**ATTACHMENT A – DRAFT CONDITIONS OF CONSENT & ATTACHMENTS**

<b>Item 3.1</b>	9.30am – 10.30am
<b>DA Number</b>	DA 308/2024/JP
<b>DA Officer</b>	Kate Clinton
<b>Applicant</b>	Landen Property Group Pty Ltd
<b>Planner</b>	James McBride, Orion Group
<b>Property Address</b>	40 Memorial Avenue, Bella Vista
<b>Proposal</b>	 <p>Residential flat development comprising 224 dwelling units over basement car parking.</p>
<b>Design review</b>	First review DA 22/11/23 Second Review DA 08/05/24
<b>Background</b>	The site has been reviewed by all Panel members.
<b>Applicant representative address to the Design Advisory Panel</b>	Architect name: James McCarthy Registration number: 10759
<b>Key Issues</b>	<p>Summary of key issues discussed:</p> <ul style="list-style-type: none"> <li>• Riparian zone interface and impact of future shared path.</li> <li>• Lack of extensive existing significant tree analysis within options for retention.</li> <li>• Encroachment of balconies and courtyard areas into setbacks common open space and resulting acoustic and amenity issues.</li> <li>• Address and main entry access to townhouse apartments blocks B1, C and D1.</li> <li>• Clarity on flood mitigation strategy - un

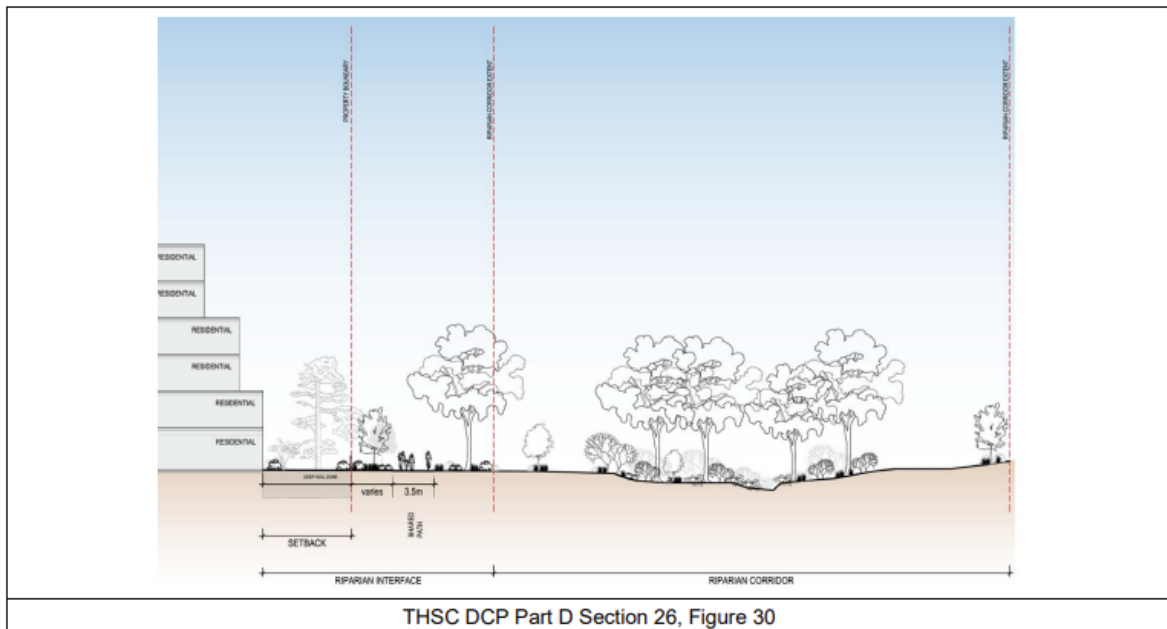
- *A number of site challenges could be mitigated by lowering of the basement car parking, including rationalisation of some of the internal gradients and tunnels. The cross site link would work better if the original ground plane was followed. Refer drawing page DA- 310-101 Rev B.*

New comment: The Panel is satisfied with the revised lowered levels of the car park and assume that this has been resolved with flood level requirements.

New comment: The Panel is of the opinion that the design changes to the cross-site link presented May 08/05/24 have resulted in a significant improvement to residential amenity,

accessibility and public domain character of the cross-site link. These revisions result in an appropriate interface at the ground level between the building and the public domain. (THSC LEP 8.6, part 4, (b) (f)(x), (xii))

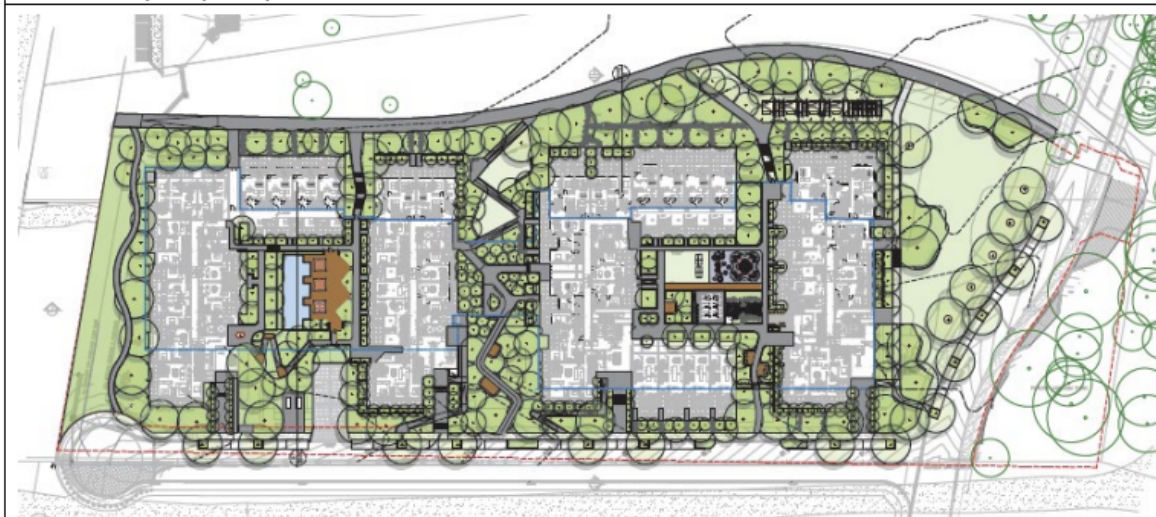
- *The Panel considers that the southern portion of landscape open space is not well utilised and recommends rotating south wing of Block A to better respond to the alignment of the proposed new road. This would enlarge and open up the central open court area, thereby providing more useable common open space, and improved solar access and residential amenity in a courtyard area that is presently dominated by the on-grade large vehicle loading and waste/storage removal facility.*

New comment: The Panel supports the revised design combining the loading dock with carpark entries. This mitigates the noise and acoustic issues that would otherwise impact upon residential amenity in building blocks A+B, and has resulted in a slightly enlarged useable common open space area that will enhance residential amenity.

The consolidation of the driveways provides a much improved street interface and public domain and gives effect to THSC LEP 2019 CL. 8.6 Part 4(b) (e).

2H Site planning and built form strategy

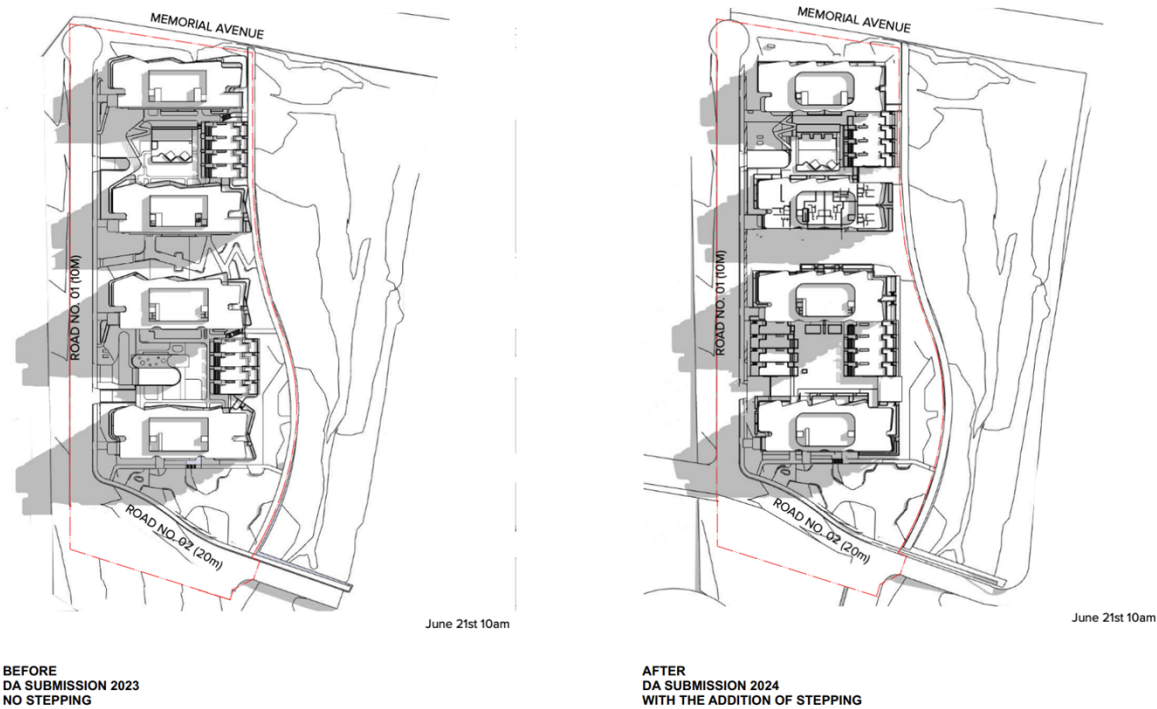
DRP COMMENT: The central court and its common areas are largely in shade as a result of the bulk and mass of the development. Adherence to setback controls would provide greater solar access into the communal open space courtyard areas.

RESPONSE: The stepping form of the building on street and riparian facing facades have been incorporated resulting in improved amenity to the courtyards

2J Bulk Scale and Massing

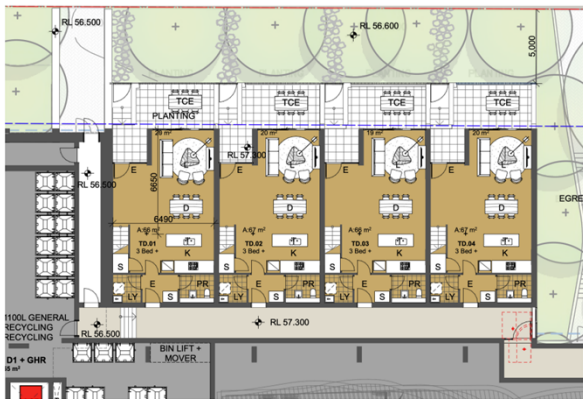
DRP COMMENT: The DCP also specifies setbacks to mitigate the visual bulk, mass and scale of the development and its public domain interface. The Panel recommends these controls be followed.

RESPONSE: The terrace to the townhouses have been setback in accordance with council allowances of 3m on Building B2 Townhouses and 5m on Building D1

2L Site Coverage and Landscaped Open Space

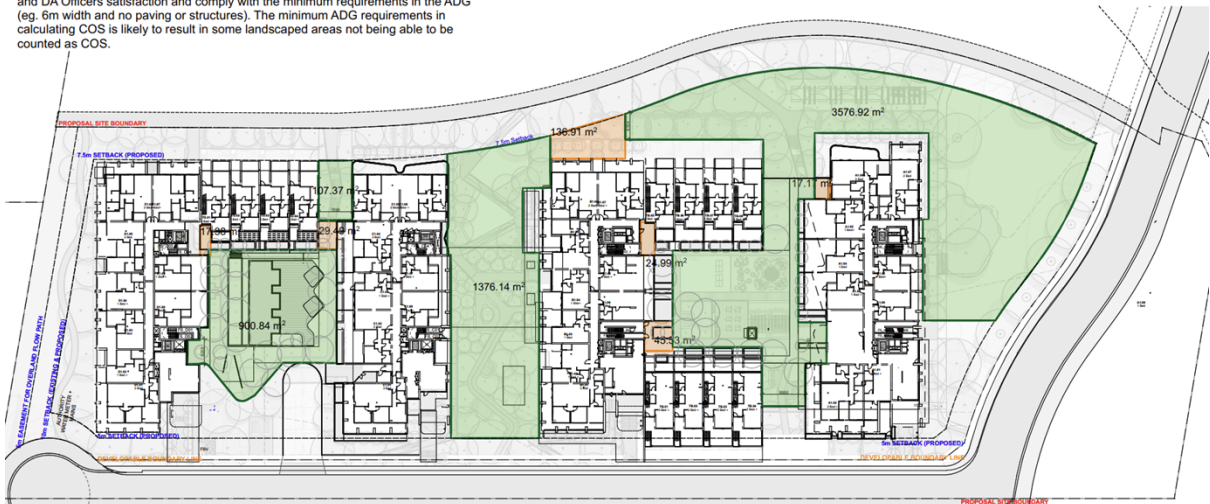
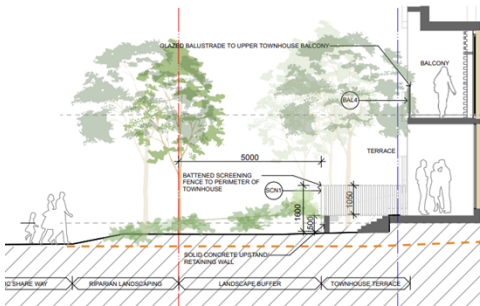
DRP COMMENT: Finalised site coverage, Landscape open space, Communal Open Space, and Deep Soil Zone (DSZ) to be provided to the Council's Landscape and DA Officers satisfaction and comply with the minimum requirements in the ADG (eg. 6m width and no paving or structures). The minimum ADG requirements in calculating COS is likely to result in some landscaped areas not being able to be counted as COS.

New Total Communal Open Space Provided:  
5880.74m<sup>2</sup> = 28.67% of developable site area

#### ACCESS ROUTES TOWNHOUSES BLDG

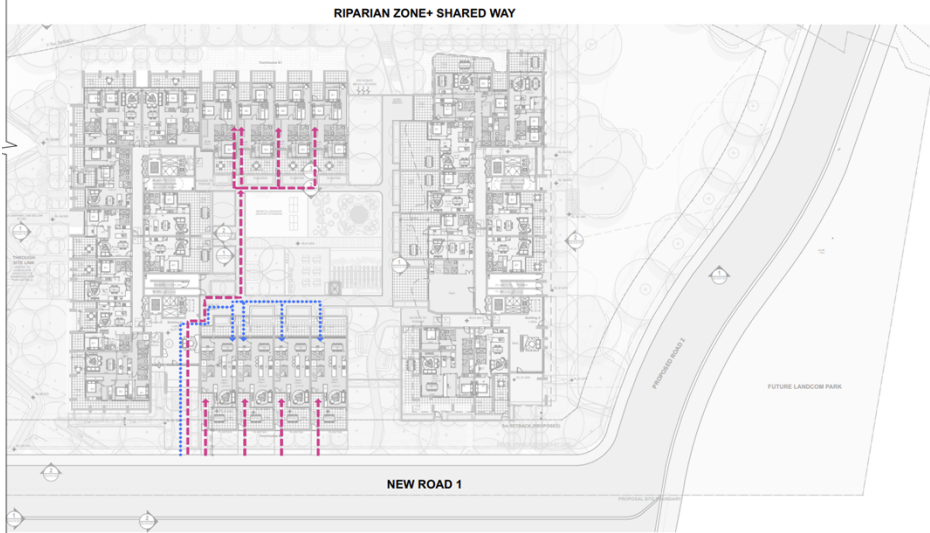
**DRP COMMENT:** The main address point and entry to Townhouses Blocks B1, C, and D1 facing riparian corridor is not resolved. What appears to be main entry at carpark/loading dock level offers poor amenity and lack of light and ventilation within corridors or the carpark area. Alternative entry address may be resolved at next level from courtyards, however for emergency, deliveries and regulatory compliance, this needs to be clarified and captured within clear wayfinding.

WAYFINDING  
ACCESS ROUTES TERRACE HOUSE  
BLDG D1 UPPER GROUND

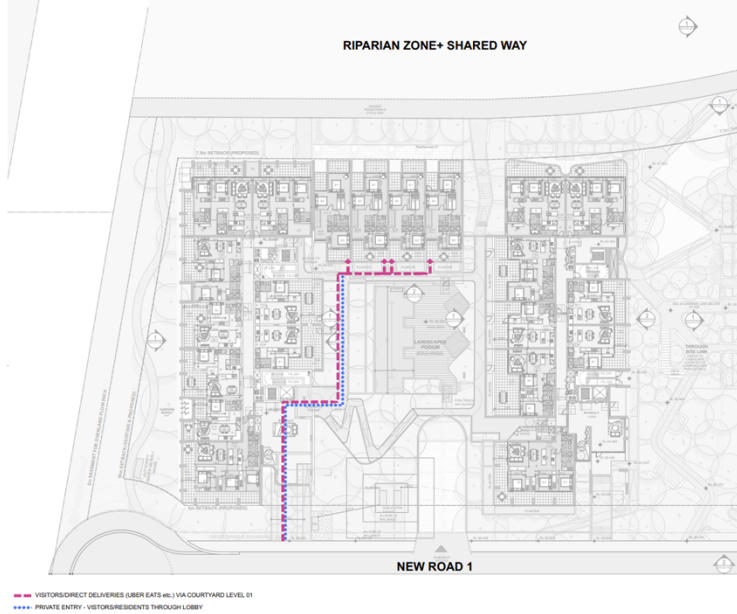
DRP COMMENT: The main address point and entry to Townhouses Blocks B1, C, and D1 facing riparian corridor is not resolved. What appears to be main entry at carpark/loading dock level offers poor amenity and lack of light and ventilation within corridors or the carpark area. Alternative entry address may be resolved at next level from courtyards, however for emergency, deliveries and regulatory compliance, this needs to be clarified and captured within clear wayfinding.

WAYFINDING  
ACCESS ROUTES TERRACE HOUSE  
BLDG D1 UPPER GROUND

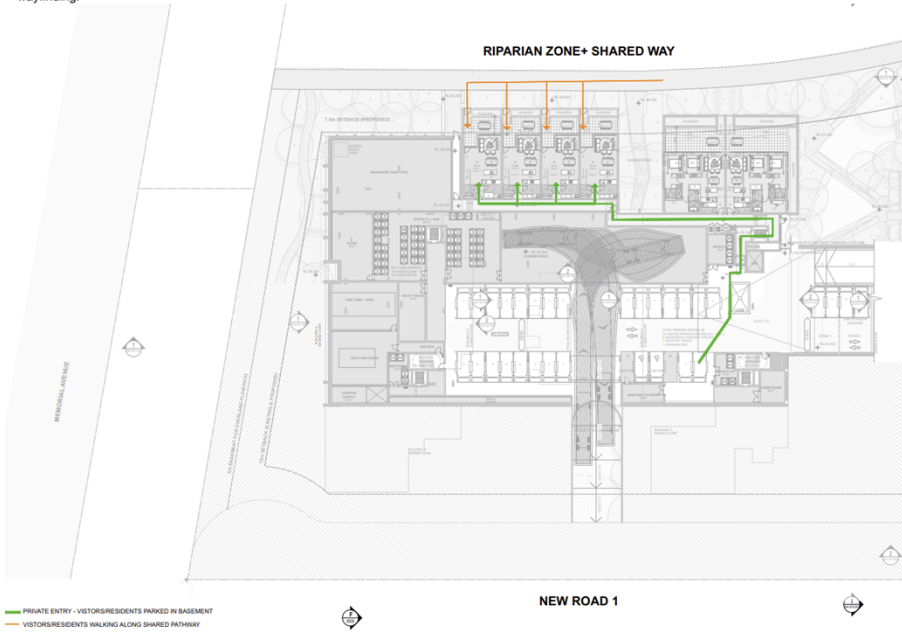
DRP COMMENT: The main address point and entry to Townhouses Blocks B1, C, and D1 facing riparian corridor is not resolved. What appears to be main entry at carpark/loading dock level offers poor amenity and lack of light and ventilation within corridors or the carpark area. Alternative entry address may be resolved at next level from courtyards, however for emergency, deliveries and regulatory compliance, this needs to be clarified and captured within clear wayfinding.

5B SEPP 65 Items  
SMOKE EXHAUST  
INTERGRATED DESIGN AWNING  
(INDICATIVE PROPOSAL)

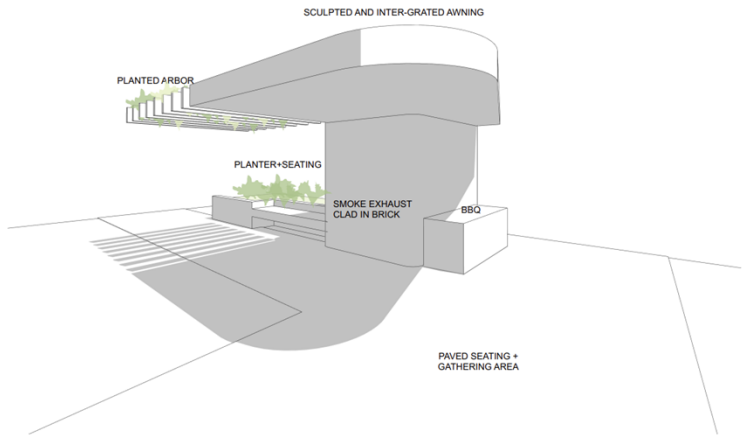
DRP COMMENT: The carpark exhaust was indicated at ground level and impacting the public domain. The Panel considers that the exhaust from the car park should not be ducted into the public domain areas such as communal open space or where residents may be impacted. General advice from the Panel is that exhaust should only occur in areas where there is not going to be a conflict of function and residential amenity, or otherwise be ducted to roof of the building. The Panel advises the current scenario does not achieve consistency with the ADG Design Criteria 4J Noise and pollution and should be resolved prior to DA submission.

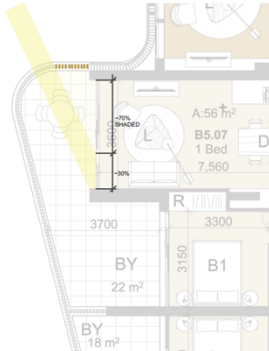
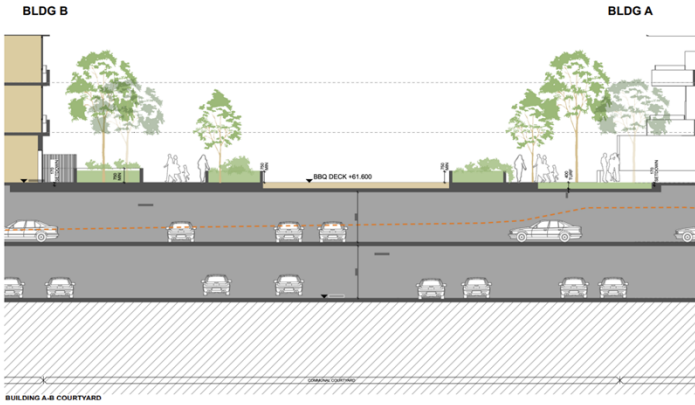
**DRP COMMENT:** Document structure and slab set downs for deep soil, swimming pool and trees in all cross sections accurately. Refer ADG Part 4P.
